HISTORIC AND DESIGN REVIEW COMMISSION

January 17, 2024

HDRC CASE NO: 2024-020
ADDRESS: 227 QUENTIN DR
LEGAL DESCRIPTION: NCB 8411 BLK 6 LOT 63
ZONING: R-6, H
CITY COUNCIL DIST.: 7
DISTRICT: Monticello Park Historic District
APPLICANT: Reed Kirksey
OWNER: Reed Kirksey
TYPE OF WORK: Construction of a 1-story, 1,752-square-foot residential structure
APPLICATION RECEIVED: December 13, 2023
60-DAY REVIEW: February 11, 2024
CASE MANAGER: Rachel Rettaliata

The applicant is requesting a Certificate of Appropriateness for the construction of a 1-story approximately 1,752-square-foot, single-family residential structure.

SITE PLAN

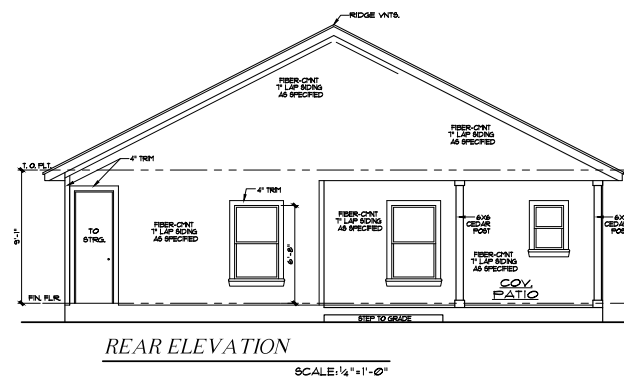
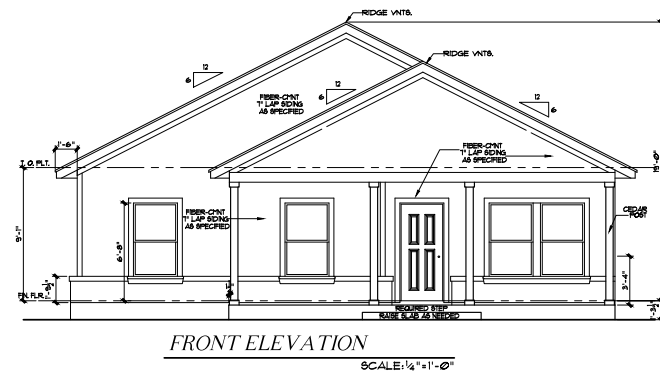
residence at 227 Quentin. The residence will be oriented toward Quentin and will match the predominant orientation of existing structures along the block. The applicant has proposed a 40-foot setback from the front porch to the property line. The submitted setback diagram shows that the new construction will be set behind the front façade wall plane of the neighboring structure on the east side of the lot; however, the structure will be located in front of the front façade wall plane of the structure on the west side of the lot, addressed as 231 Quentin. Staff finds that the front setback should be increased so that it is aligned with the neighboring setback at 231 Quentin.

- i. That the front setback is increased so that the new construction aligns with the neighboring setback at 231 Quentin based on finding d. An updated site plan must be submitted to staff for review and approval prior to the issuance of a Certificate of Appropriateness.

RIGHT ELEVATION
SCALE: 1/4"=1'-0"

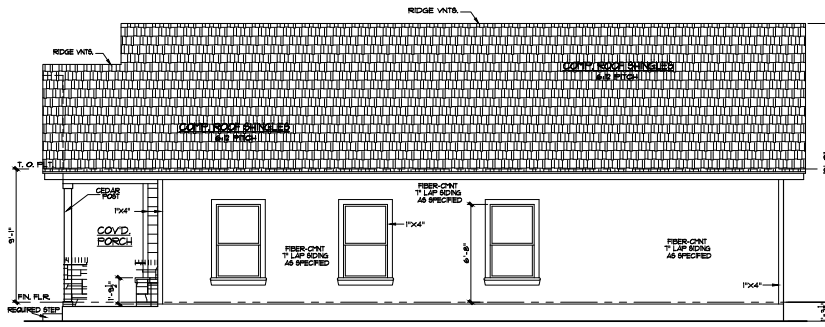
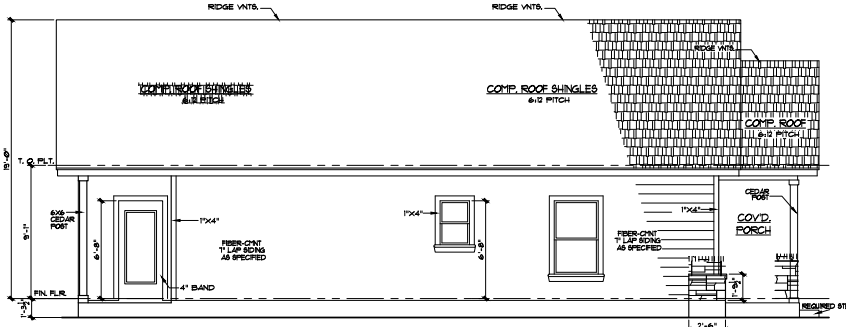
- iii. That the applicant modifies the roof pitch to be in keeping with the predominant lower-sloped roofs of adjacent structures based on finding f. Updated elevation drawings must be submitted to staff for review prior to returning to the HDRC. ***This stipulation has NOT been met.***

- f. **ROOF FORM** – The applicant has proposed a front gable roof form with overhanging eaves and a projecting front gable porch roof. According to Guideline 2.B.i for New Construction, new construction should feature roof forms that are consistent with those predominantly found on the block. The adjacent structures on Quentin feature cross gable, side gable, and hip roof forms. The structures immediately adjacent to the property predominately feature low-slope roofs. The proposed roof form features a 6:12 pitch and a wide gable span. Staff finds that the applicant should modify the roof pitch to be in keeping with the lower-sloped roofs along this block of Quentin.

- ii. That the applicant modifies the roof pitch to be in keeping with the predominant lower-sloped roofs of adjacent structures based on finding f. Updated elevation drawings must be submitted to staff for review prior to returning to the HDRC.

EXTERIOR DETAILS

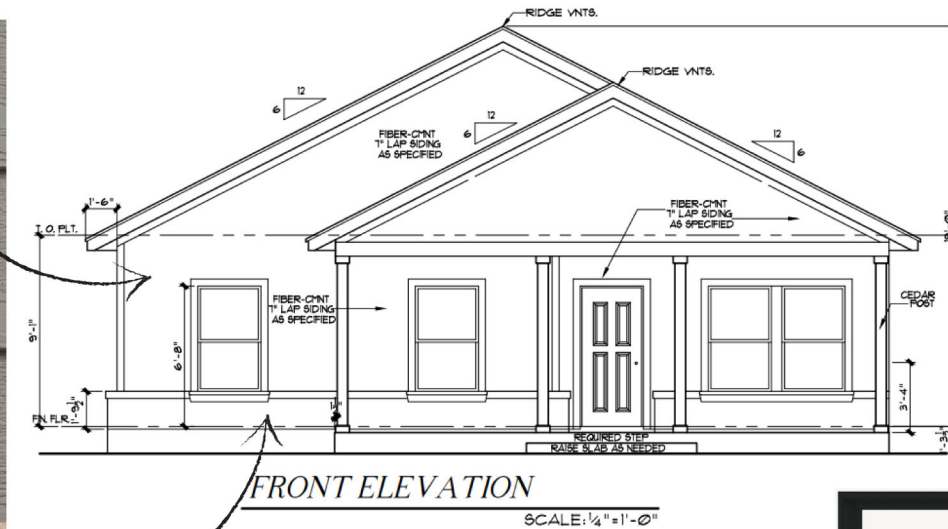
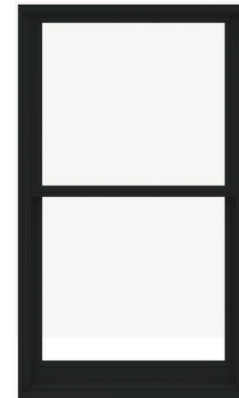
- h. **MATERIALS AND TEXTURES** – The applicant has proposed to construct the residence using fiber cement siding, brick skirting, wood post columns on rock bases, and a composition shingle roof. Guideline 3.A.i for New Construction stipulates that new construction should use materials that complement the type, color, and texture of materials traditionally found in the district. Materials should not be so dissimilar as to distract from the historic interpretation of the district. For example, corrugated metal siding would not be appropriate for a new structure in a district comprised of homes with wood siding. Consider using traditional materials, such as wood siding, in a new way to provide visual interest in new construction while still ensuring compatibility. Structures on the immediate block feature brick, masonry, composition, and shingle cladding. Primary structures along Quentin rarely feature a skirting material that differs from the main cladding material; however, a few houses on the immediate block feature brick or masonry skirting or accent material. Staff finds that the fiber cement siding should feature a reveal of no more than 6 inches and a smooth texture.

- i. **WINDOW MATERIALS** – The applicant has proposed to install Anderson 400 Series clad windows. Wood or aluminum-clad wood windows are recommended and should feature an inset of two (2) inches within facades and should feature profiles that are found historically within the immediate vicinity. An alternative window material may be proposed, provided that the window features meeting rails that are no taller than 1.25" and stiles no wider than 2.25". White manufacturer's color is not allowed, and color selection must be presented to staff. There should be a minimum of two inches in depth between the front face of the window trim and the front face of the top window sash. This must be accomplished by recessing the window sufficiently within the opening or with the installation of additional window trim to add thickness. Window trim must feature traditional dimensions and an architecturally appropriate sill detail. Window track components must be painted to match the window trim or be concealed by a wood window screen set within the opening. Faux divided lites are not permitted. Staff finds that the applicant should submit final product specifications to staff for review.

LAWNSCAPE DETAILS

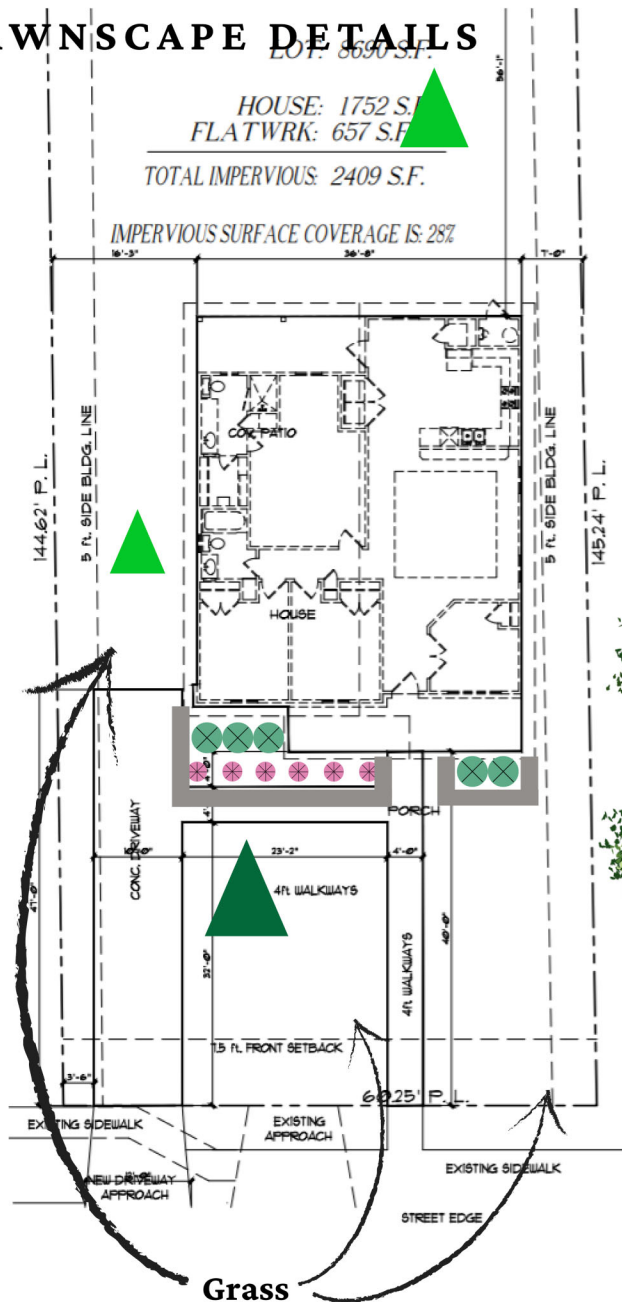
- o. **LANDSCAPING PLAN** – The applicant has submitted a landscaping plan showing proposals for grass lawns and front yard planters with flagstone borders. Staff finds the proposal generally appropriate and finds that height specifications and final material specifications for any retaining walls or curbing installed for the planters should be submitted to staff for review.

- v. That the applicant submits height specifications for any retaining walls or curbing installed for the proposed planters to staff for review prior to the issuance of a Certificate of Appropriateness based on finding o.

SITE PLAN
& ELEVATIONS

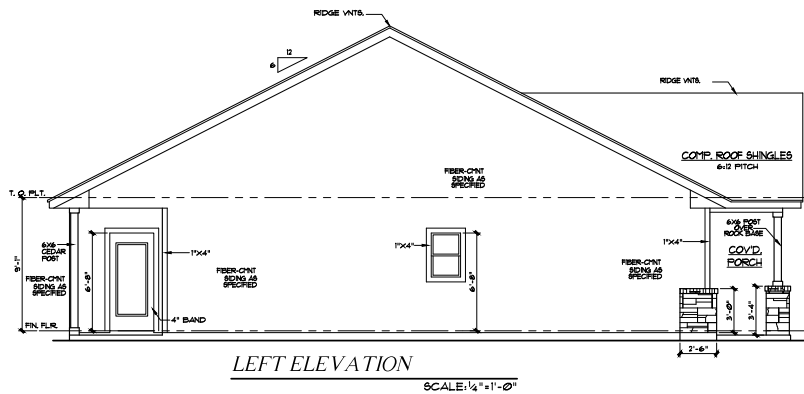
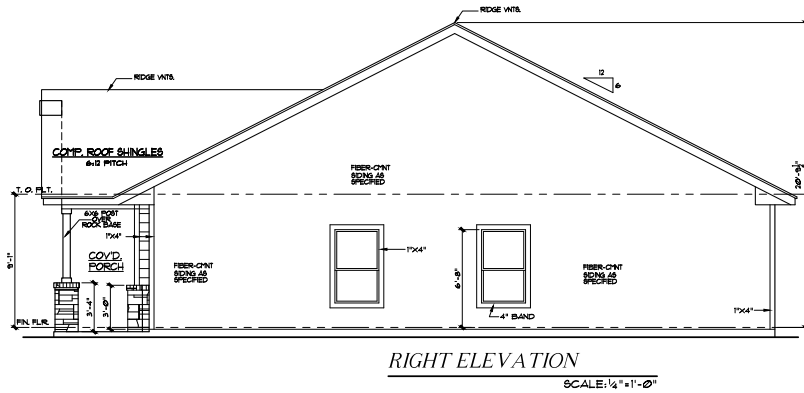
MS: I will agree with Lisa's roof suggestions. There are houses that have large roof planes; however, the ridge height is usually lower. This roof, even though it is a simple gable roof form, it does seem awkward and tall. You can play with the roof design and there are several different solutions so that the roof form can break up that mass in manageable dimensions.

JF: On the left elevation, you have turned the corner with your stone wainscot but that is not the same for the right elevation. I would recommend that those skirts should match. If you are planning to fence the property, coming to the skirt with the fence would be a good stopping point for privacy fencing.
